**Subject: Maverik Gas and Convenience Store Traffic Impact Study  
Unser and Los Volcanes, South of I-40  
Albuquerque, Bernalillo County, New Mexico**

This letter is to inform you that the **FINAL** Traffic Impact Study (TIS) for the proposed Maverik Store on the southeast quadrant of Unser Blvd. and Los Volcanes Rd. just south of I-40 dated March 3, 2019 has been reviewed.

Nancy R. Perea, P.E.  
District 3 Traffic Engineer

## EXHIBIT A

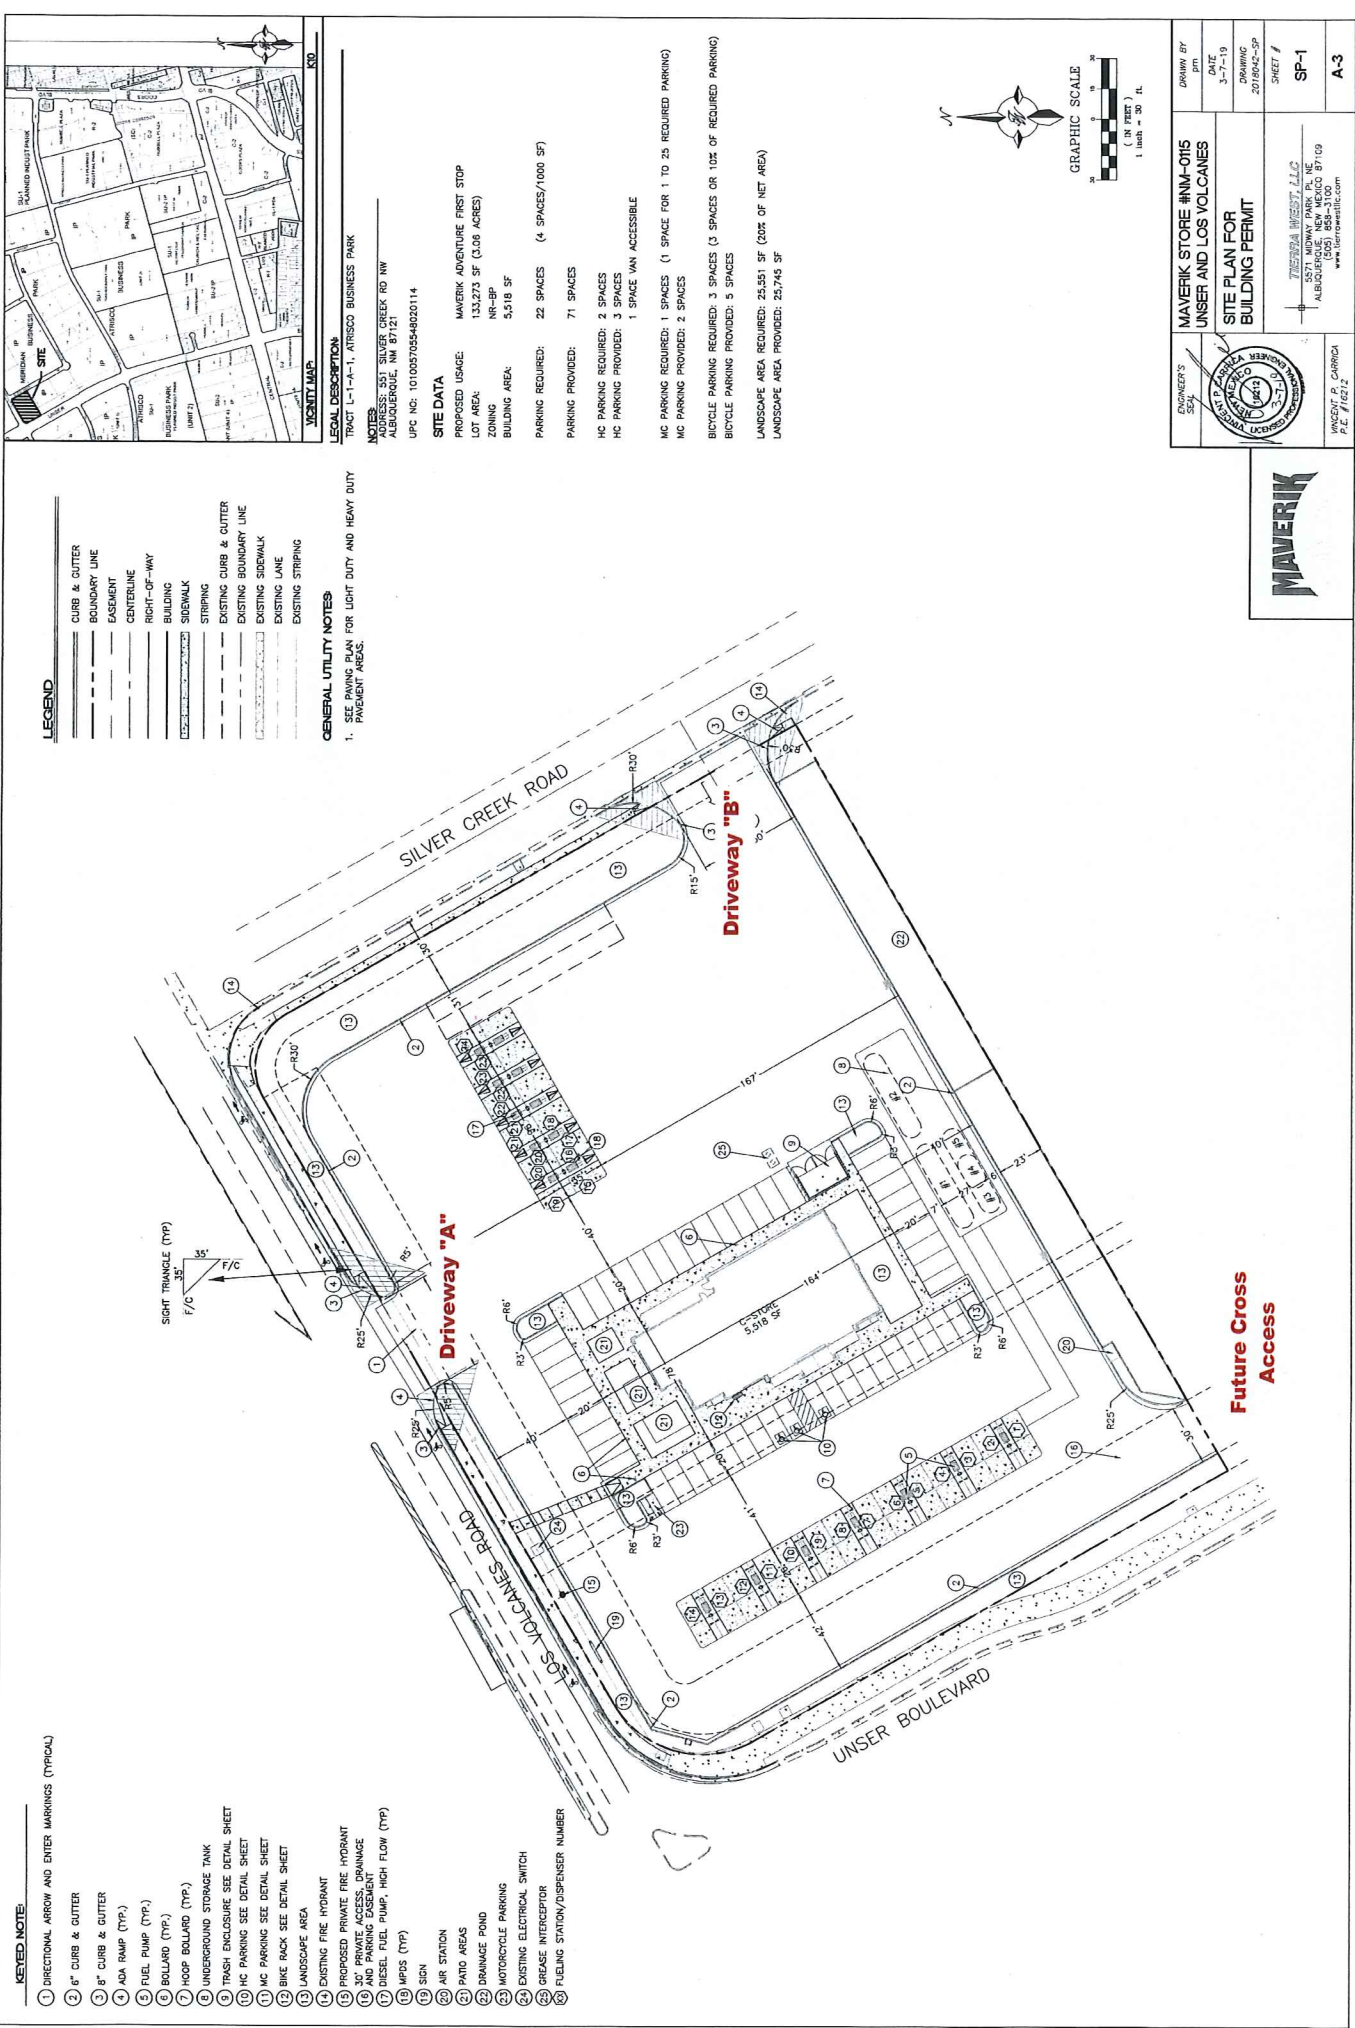
The NMDOT has no objection to the Maverik Store as proposed on the site plan shown in Exhibit A. NMDOT gives final concurrence of this development given the conditions below are met. This TIS proposed the recommendations shown in Exhibit B.

1. The development shall extend the existing southbound left turn lane at Unser Blvd. and Los Volcanes Rd. from 100 feet to 400 feet.
2. The development shall convert the southbound left turn lanes at Unser Blvd. and Los Volcanes Rd. into protected movements only. All equipment shall be installed and the signal timing shall be provided to the NMDOT and City of Albuquerque Traffic Section for concurrence.
3. The development should dedicate property along Los Volcanes Rd. to provide an additional lane for the westbound approach. Final lanes should be dual left turn lanes, one dedicated through lane, and one dedicated right turn lane. See Exhibit C for proposed restriping recommendation.
4. The NMDOT shall provide final approval on the design for the offsite improvements. The developer shall agree to incorporate all the comments requested by the NMDOT.
